17.7.0 ARCHITECTURAL HERITAGE IMPACT ASSESSMENT OF THE PLANNING SCHEME RELATED TO THE POINT DEPOT

17.7.1 Excerpt from the Amended Planning Scheme

17.12.0 ARCHITECTURAL HERITAGE IMPACT ASSESSMENT ON NOS. 91 – 94 NORTH WALL QUAY, DUBLIN 1

Diagram 4 of Proposed Amendment: Indicative View

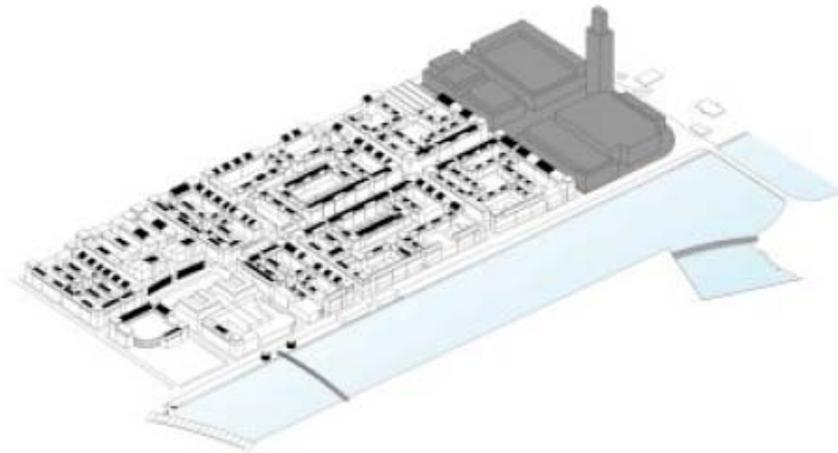
Diagram 4 lacks clarity and is not sufficiently explicit to fully convey the volumetric parameters. The volumetric diagram to which Principle 8 refers should be detailed and explicit.

Diagram 5 of the Proposed Amendments: Building Heights

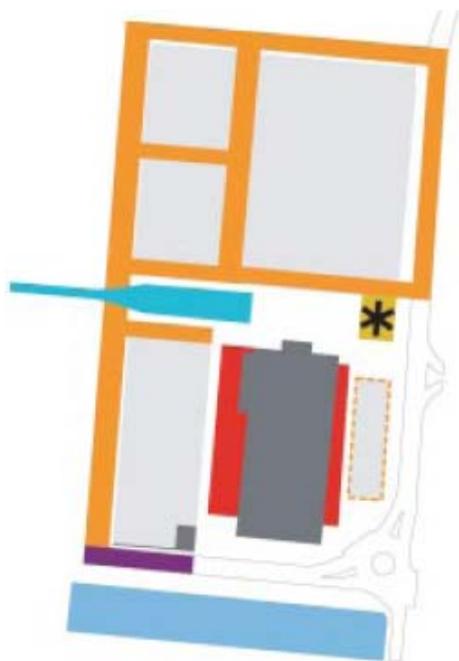
Diagram 5: the note concerning commercial retail is ambiguous and should be clarified.
